Applies To: **1999–2000 Odyssey EX – ALL**
2001 Odyssey EX – From VIN 2HKRL18..1H500001 thru 2HKRL18..1H521371

August 7, 2001

Driver’s Seat-Back Sometimes Changes Position

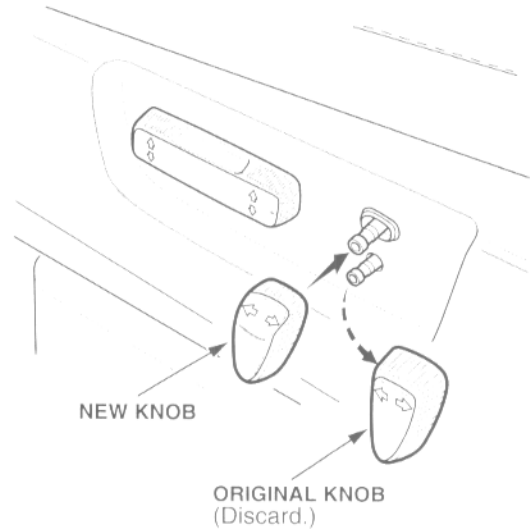
The driver’s seat recline knob is too long, allowing the driver to accidentally bump the switch with his or her thigh when entering or exiting the vehicle.

Replace the recline knob.

1. Remove the original knob by pulling it away from the seat.

2. Install the new knob, making sure that the forward and backward arrows are at the top.
